# TECHNICAL BULLETIN

Product: VFL-900HD Viewfinder

Symptom: No operation due to blown fuse

FIGURE 1

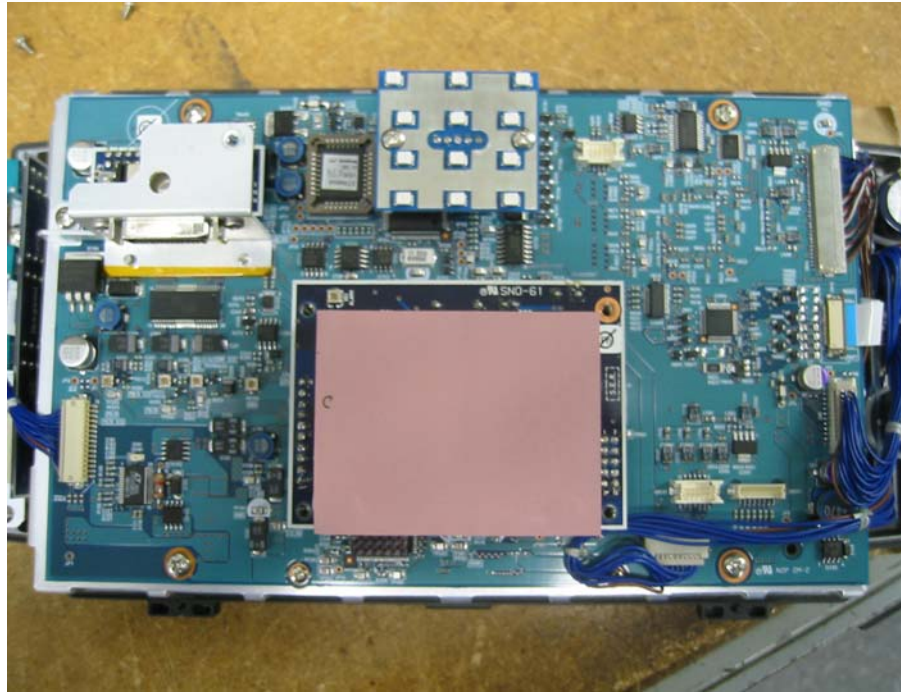
When the viewfinder is turned on, the surge current may be high enough to cause the fast-acting fuse, F1, to open. To correct this problem, it is recommended to change F1 to a Slo Blo type fuse.

1. On the back of the viewfinder, remove the connector cover, then remove the interconnect cable.
2. Remove the 5 screws holding the rear cover in place. ( 2 top, 2 bottom, 1 by the connector cover.
3. Remove the power module (4 screws). This module has a red heat sink on it. Refer to Fig. 1.
4. Remove Fuse F1, located on the component side of the power module. This component is located on the left side of the board. Refer to Fig. 2
5. Replace with a 2.5A Slo Blo fuse.
6. Reinstall the power module, rear cover, interconnect cable, and connector cover.

Fuse, 2.5A Slo Blo, P/N 046002.5VR
